Delegated Report		Analysis sheet		Expiry Date:	08/06/2021
		N/A		Consultation Expiry Date:	31/08/2021
Officer			Application Number(s)		
David Peres Da Costa			2021/1782/P		
Application Address			Drawing Numbers		
Glebe House 15 Fitzroy Mews London W1T 6DP			Refer to draft decision notice		
PO 3/4	Area Team Signature	C&UD	Authorised Officer Signature		
Proposal(s)					
Erection of an additional storey to create a residential dwelling.					
Recommendation(s):		Refuse Planning Permission			
Application Type:		Full planning permission

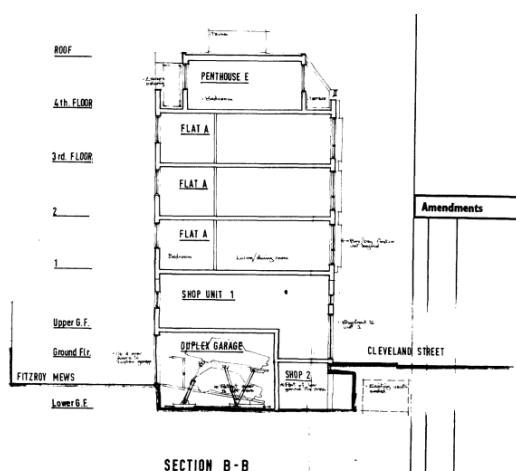
2.18. The top floor addition is poorly designed in its footprint, bulk and integration with the existing building. When viewed from Cleveland Street, the conversion of the existing set-back top floor would create, in effect, a very dominant double mansard, a two-storey form atop a four-story building, that would be at odds with the scale and post-war style of the building. The height of the extension (3.1m) is also greater than the height of the floors below

(approx. 2.65m) as it incorporates a structural floor above the roof of the existing fourth floor. This height differential would add to the bulky appearance of the extension. In addition it is noted that the height of the rooftop plant room and access stair does not appear to be accurate. This structure is shown as approx. 1.1m high but contains an access stair and lift overrun. The existing roof structure is approx. 1.79m high and it is likely that the proposed rooftop structure would need to be of a similar scale to allow access to the stairs.

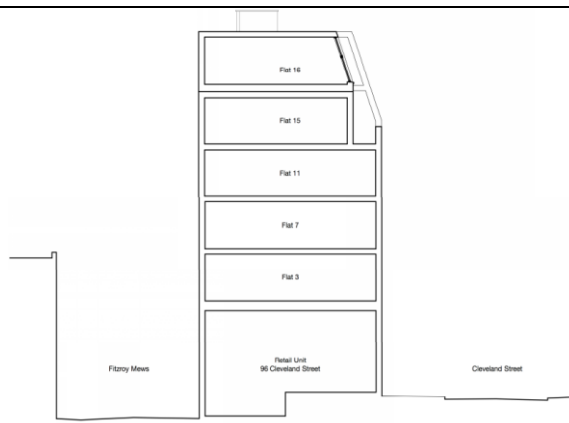
- 2.22. Paragraph 6.33 of the Conservation Area Statement (CAS) notes that “Fitzroy Mews retains its granite sett surface but has no buildings of note. The three-storey 20th century houses and offices on the eastern side take on a mews character and have large ground-floor openings with timber doors.” The CAS also acknowledges that “the eastern side of the mews is dominated by five-storey red brick blocks of flats which have access walkways and balconies to the rear above first floor level.” The existing building has sets back at top floor level, so as to minimise its impact on to Cleveland Street, and more importantly the narrow Fitzroy Mews. This can be seen in the approved section drawings for the original permission 7465(R) as shown below.

- 2.23. The proposal overhangs this existing 4th floor on the Fitzroy Mews façade, so that it forms a looming presence on to this street with inappropriate bulk to this lower scale setting. Part of the supporting structure for the extension is only 1.35m from the east facing living room window of Flat 14 on the fourth floor of the application site.

- 2.24. It is considered that the addition of an extra storey to Glebe House would make it even more prominent within the Mews and detract from the character and appearance of the Mews and the wider conservation area. The additional storey would appear overbearing when viewed from Fitzroy Mews.
